STAFF REPORT: 05-12-21 MEETING

APPLICATION NUMBER: 21-7222

ADDRESS: 1920 ATKINSON

SCOPE: REHABILITATE HOUSE FOR ADAPTIVE REUSE AS RESTAURANT/APTS; BUILD EXTERIOR PATIO AT REAR

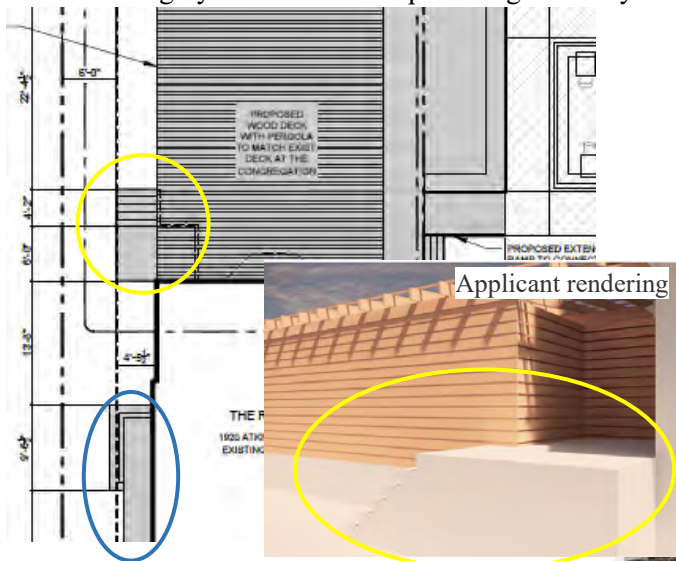
- Residential Entrance - The stairs that will be constructed for the new entrance will extend to the west, beyond the NW corner of the house. The outer edge of the rear stairs/platform will align with the outer edge of the existing porch that starts at the house's front door, as confirmed in the below site plan. The applicant confirmed the new stairs and landing will need a railing, and the landing will be 1'-5" taller than the front porch. Due to the close adjacency of the neighboring property and its rear corner location, the increased height will not be highly visible from the public right-of-way.

- New stair/platform for rear entrance to residential units
- Existing front entrance porch/platform

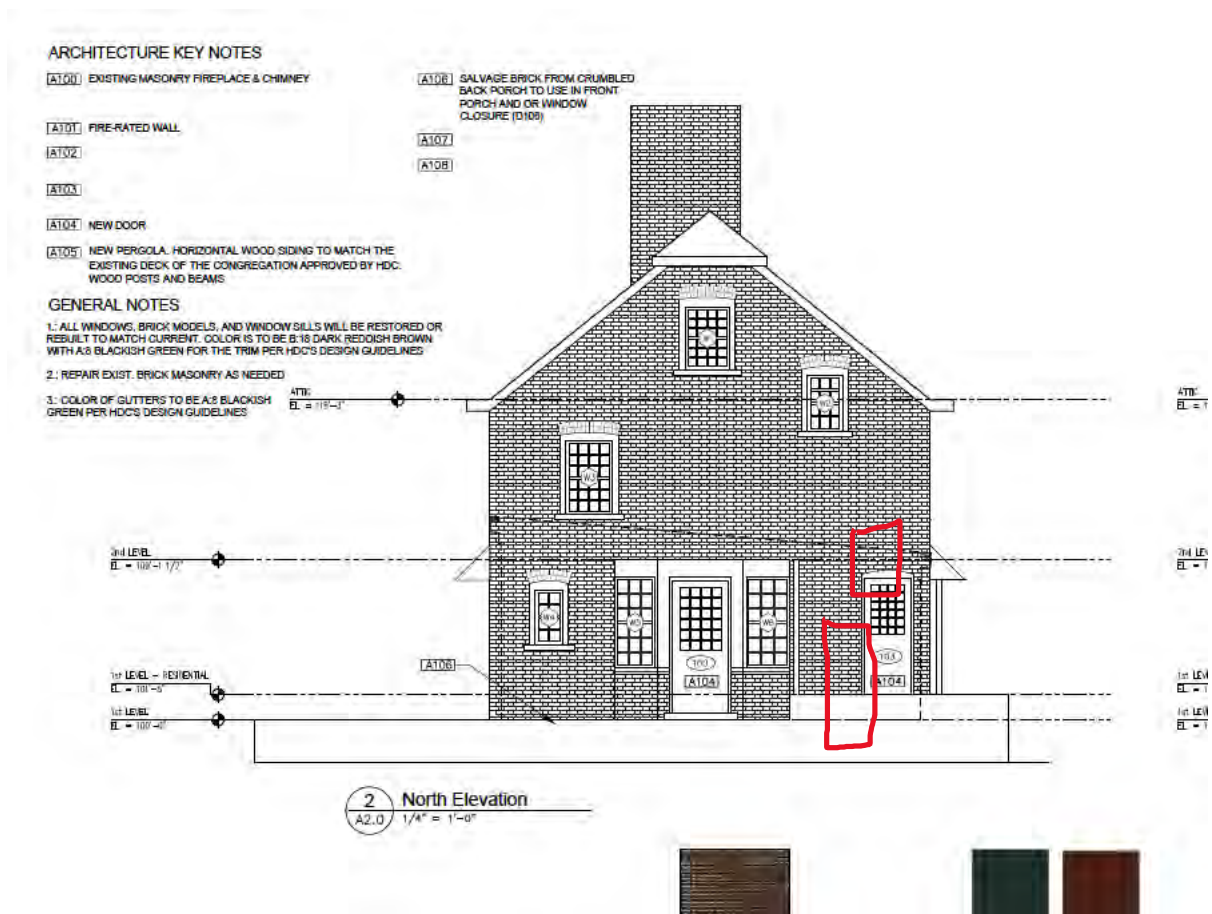
The removal of the existing rear entry and the construction of a new door closer to the NW corner of the house is not listed within the scope of work. Please add this to the project list.

Please see this snapshot from Page 5 of the drawings submitted to you where the window has been bricked in and the door moved higher and farther West. I drew in some redlines where they used to be. Sorry if you have seen this already and you are exclusively referencing the Narrative/Scope of Work.

The following language was also added to the Narrative:

03: Move Door (D103) higher and further west to accommodate for the New Residential Door Entrance (103) at the back of the building.

1 Demo. North Elevation
D2.0 1/4" = 1'-0"

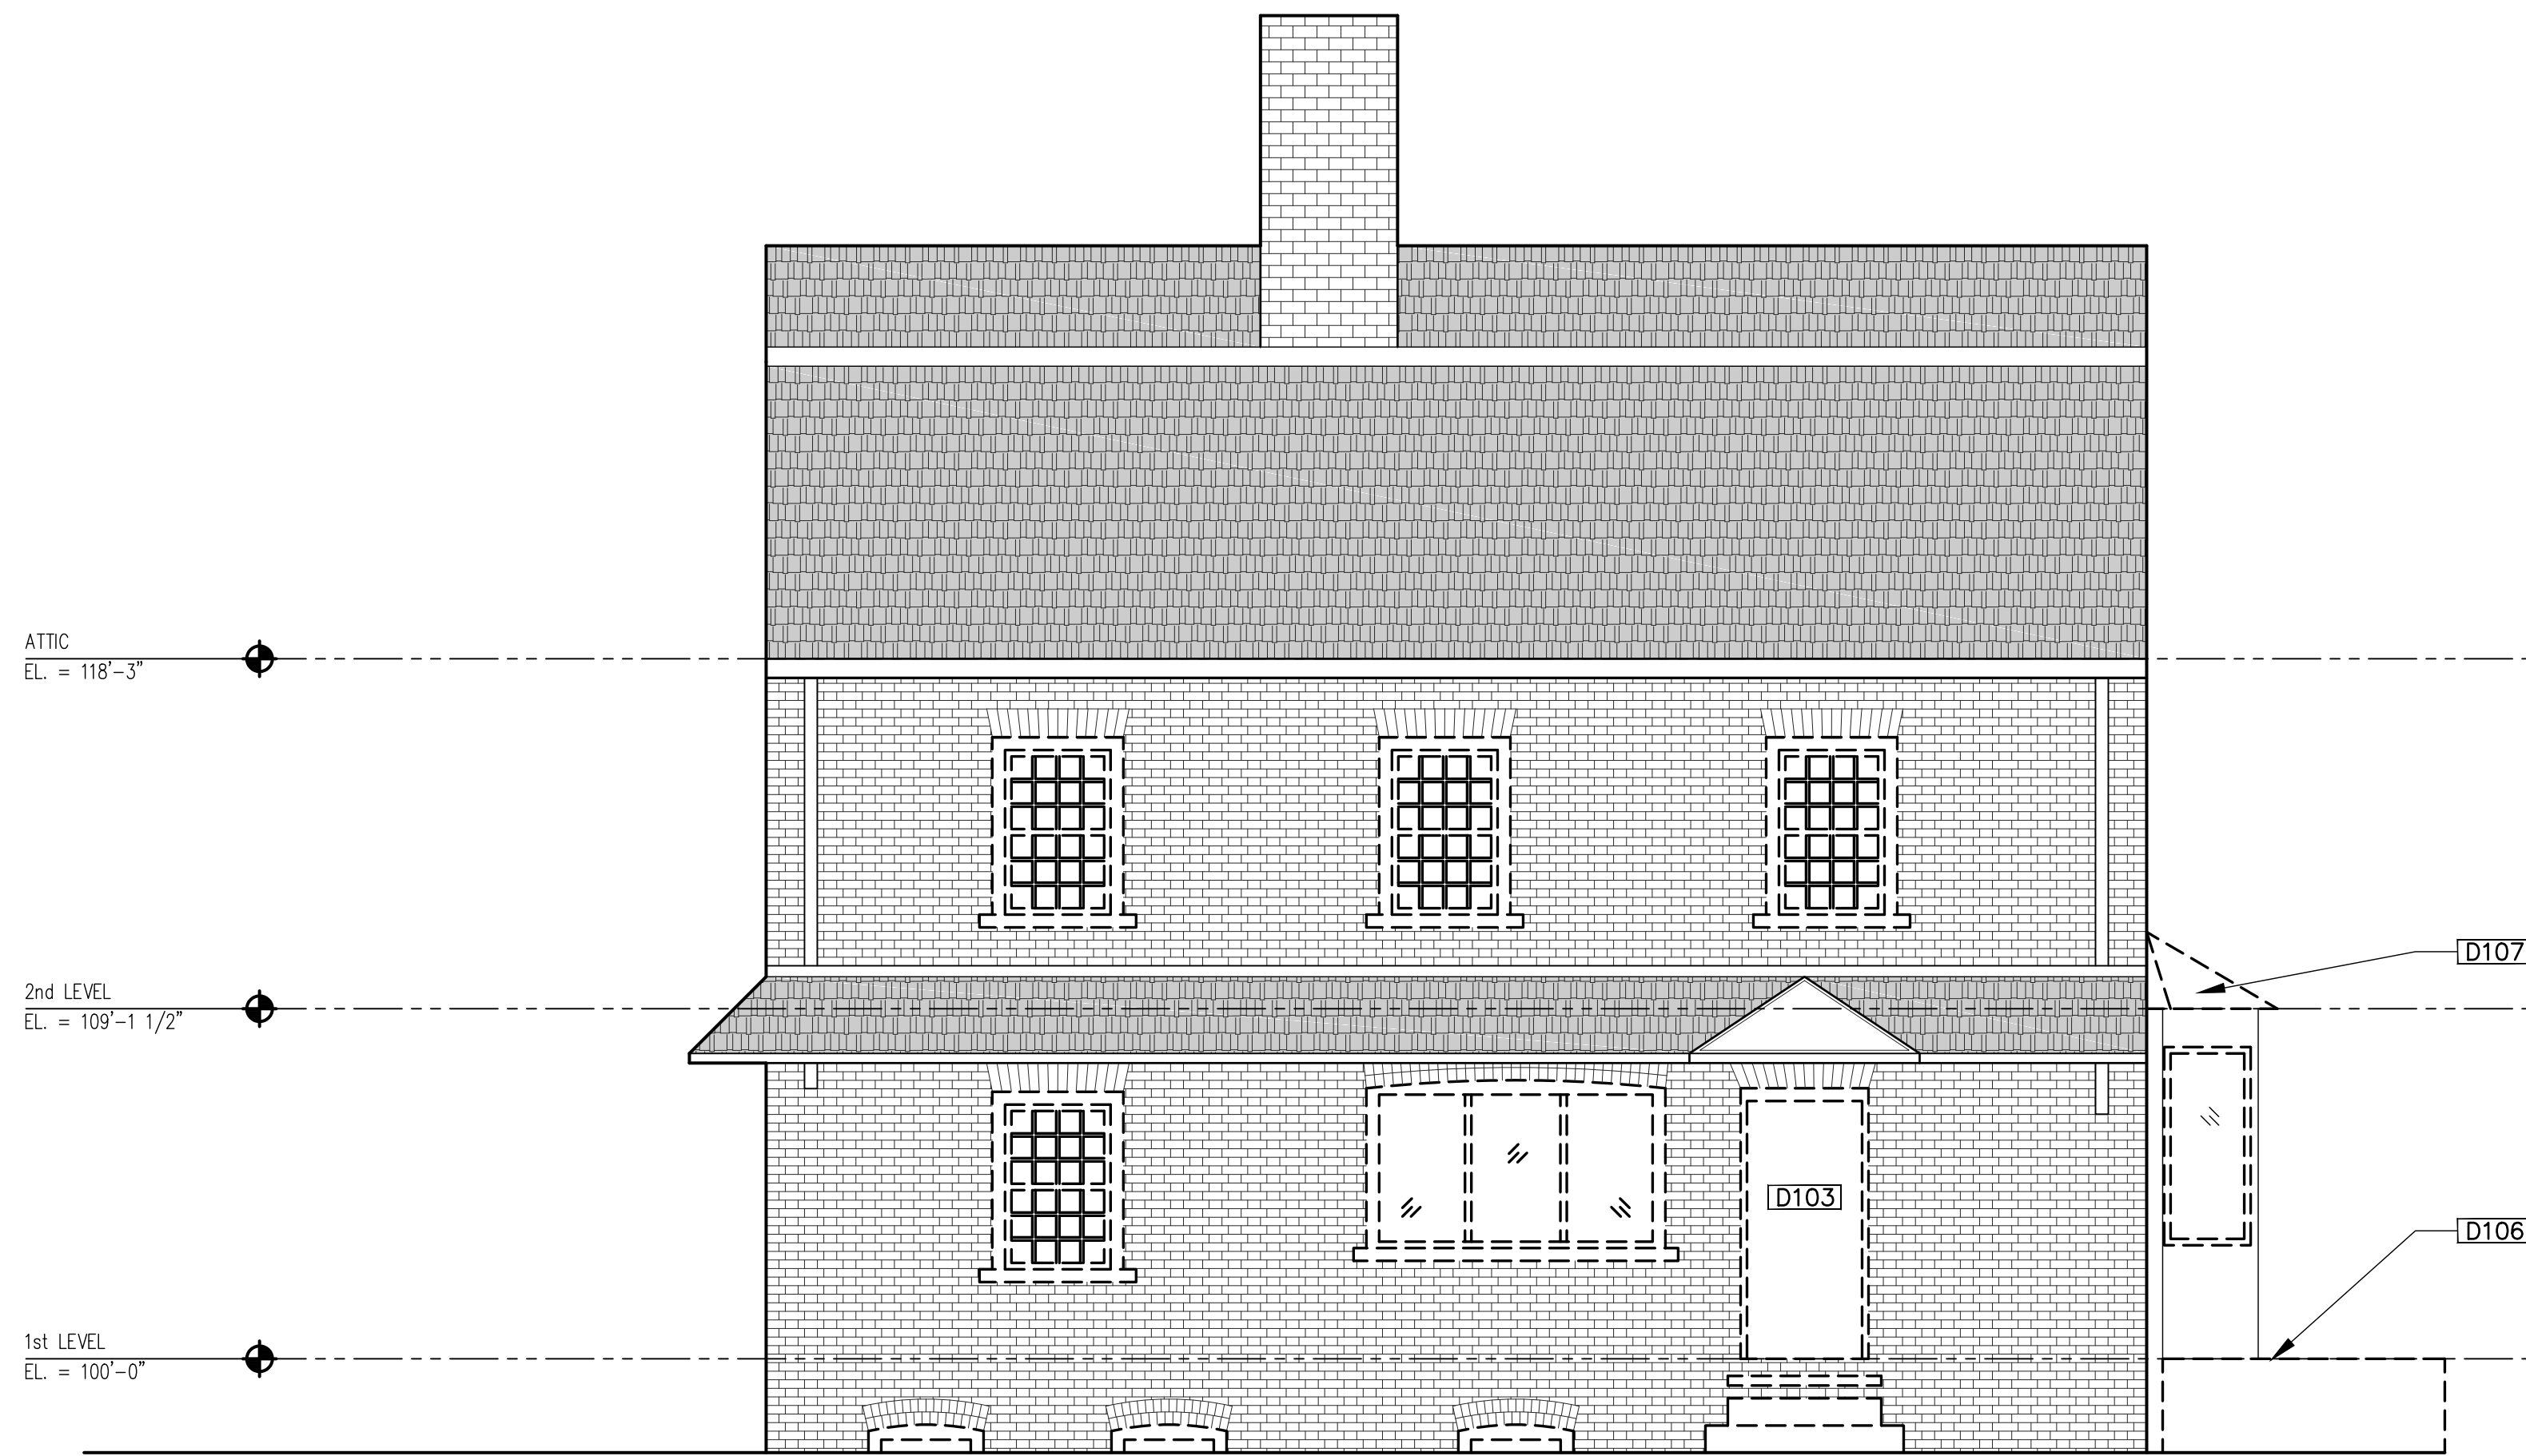
- Window and door removal on rear/north elevation. The elevation drawing shows the two openings removed (including double rowlock headers and brick toothed in), erasing all evidence of the historic openings. Per the proposal, it appears the sloping pergola roof (shown on the elevation as a sloping black line) will cross the window opening creating the need for a flat surface.

- A catalog cut for the rear entry railing will be submitted for staff review.
- Evidence of the window and door opening proposed for removal on the rear elevation will be retained and will consist of: the double rowlock headers and the brick infill will be laid in a running bond pattern within the openings. Vertical joints will be used to separate the infill brick from the existing brick wall.
